### UDPRP Review Summary 03.22.13

Urban Design Peer Review Panel

PROJECT: Flora Lofts

## 2121 Flora St.

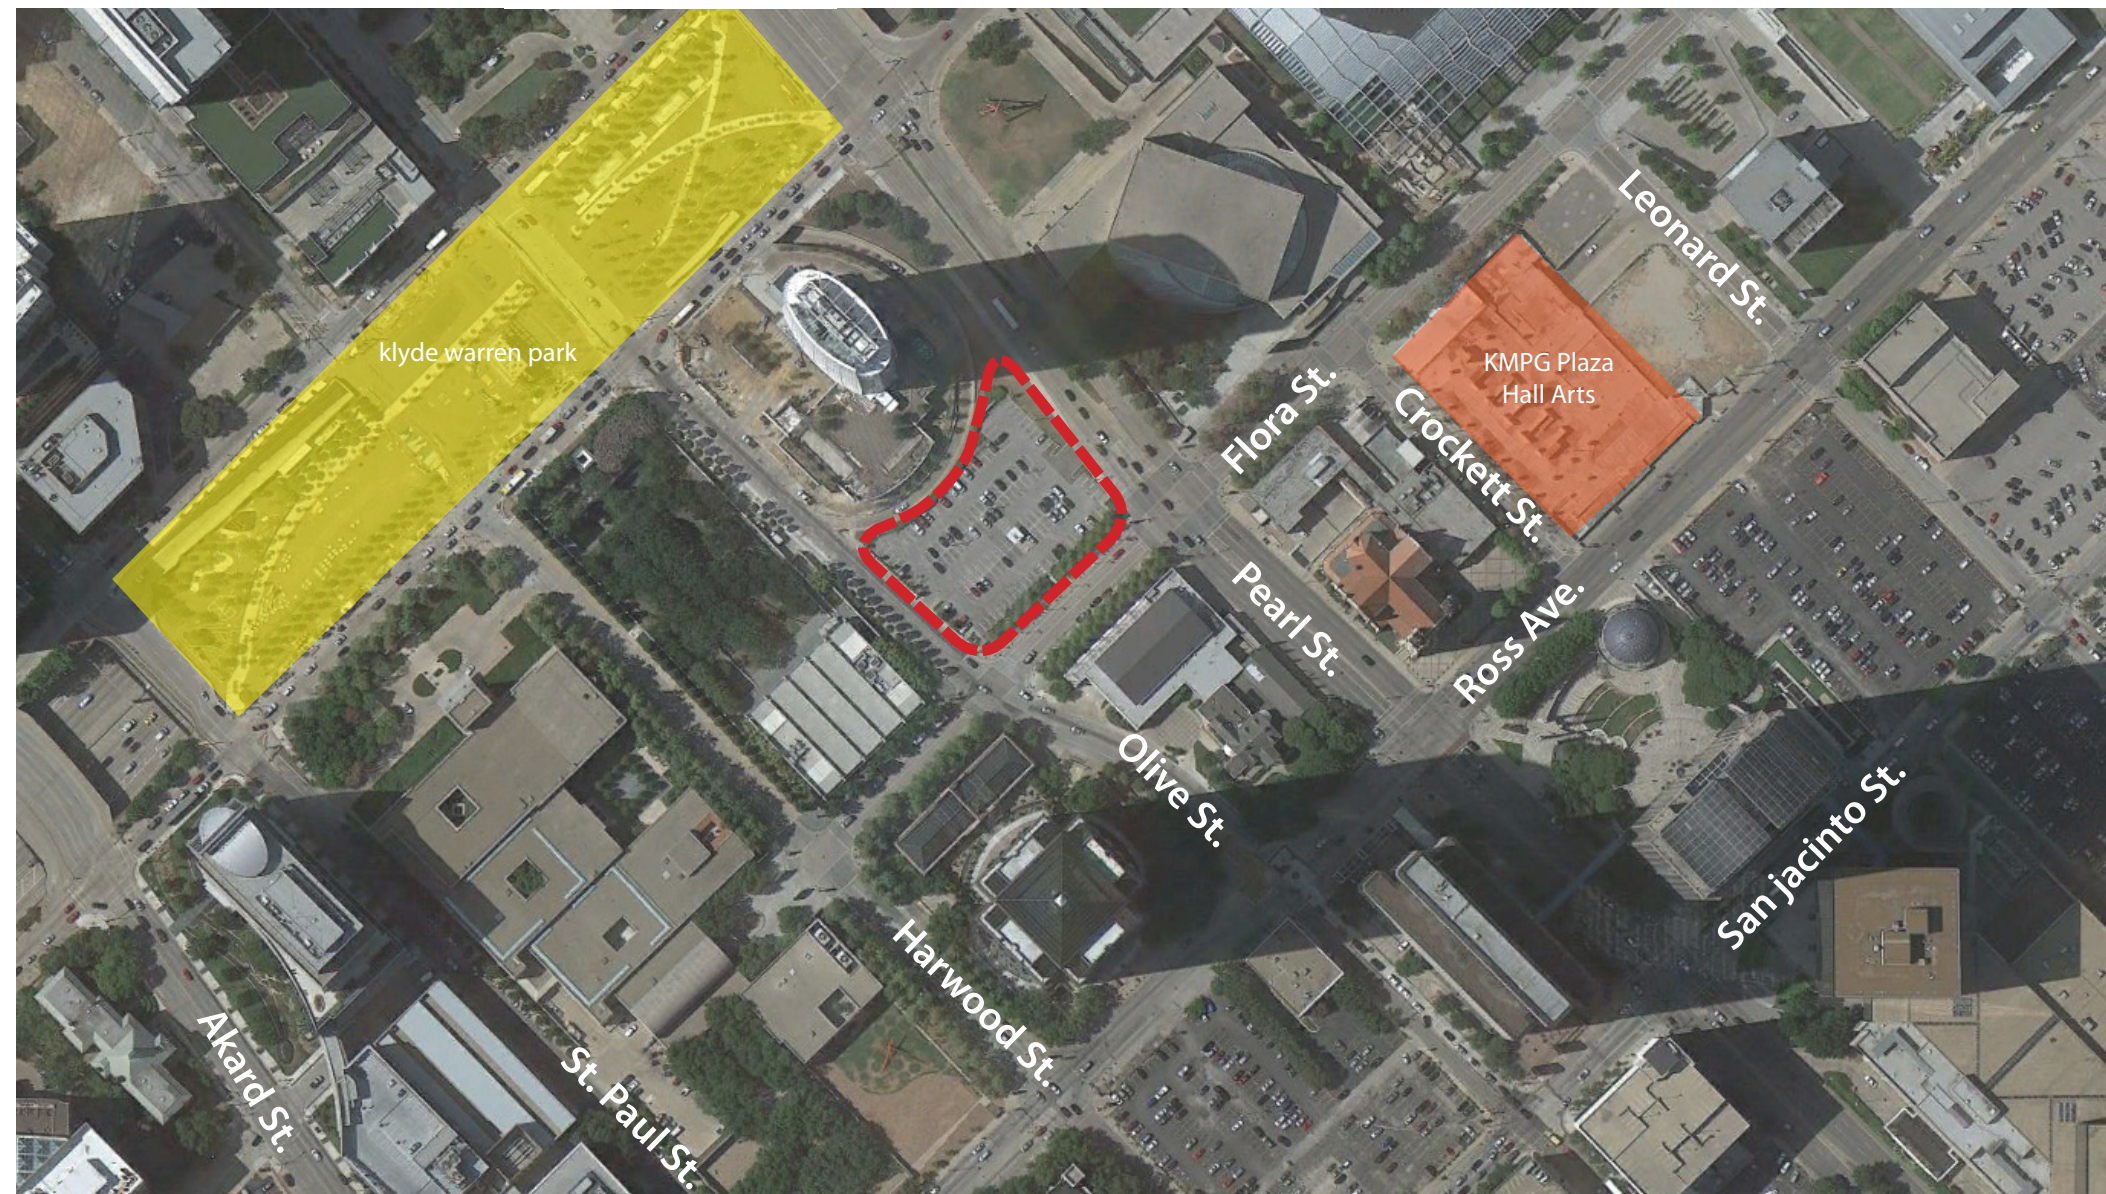
#### Advice Summary

- [1] Relative to the architecture of the building and the social impulse of the project the panel is extremely positive about the proposal.
- [2] Diagrammatic representation showing how subsequent phases will address the perimeter of the urban block and street edges should be developed noting edge condition at street level, entrance locations and service areas.

NEW PEDESTRIAN CONNECTION TO KLYDE WARREN PARK

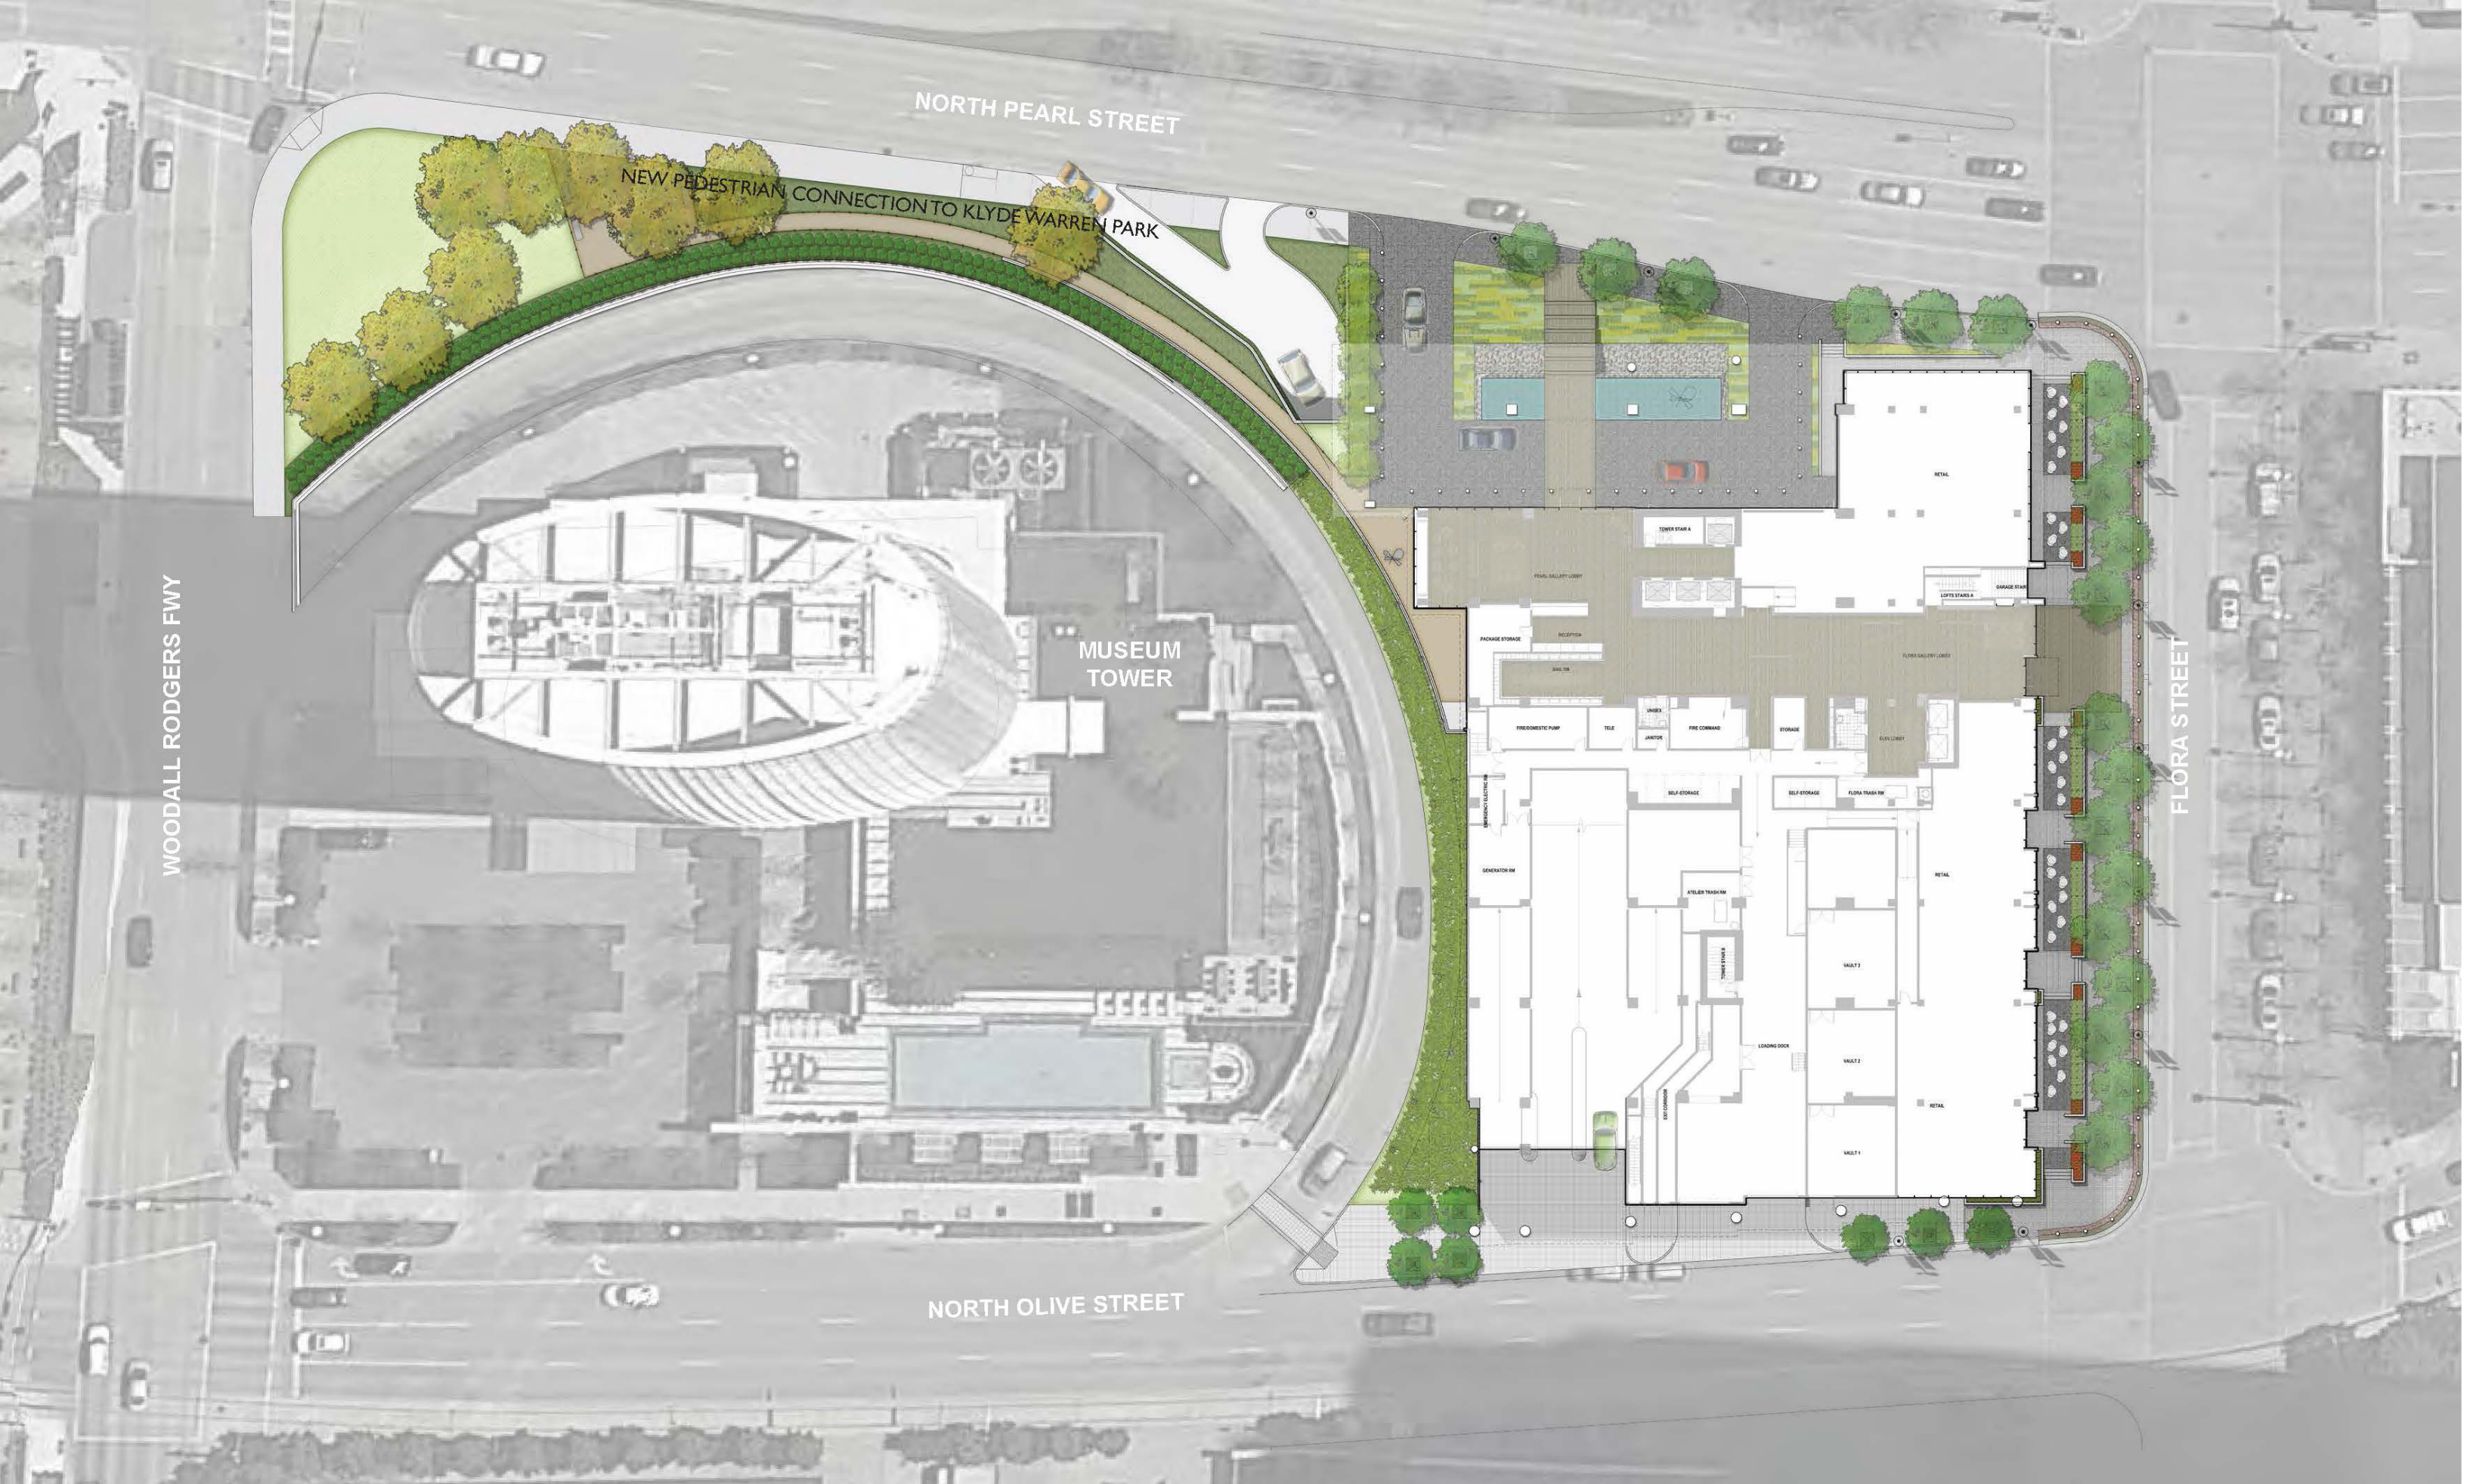
- [1] Attention should be given to the treatment of the pedestrian experience along both Pearl and St. Paul to create inviting pedestrian connections to the park -

Consideration should be given to condensing or combining garage access drives in order to minimize their impact on the public realm and enhance pedestrian connections to the park.
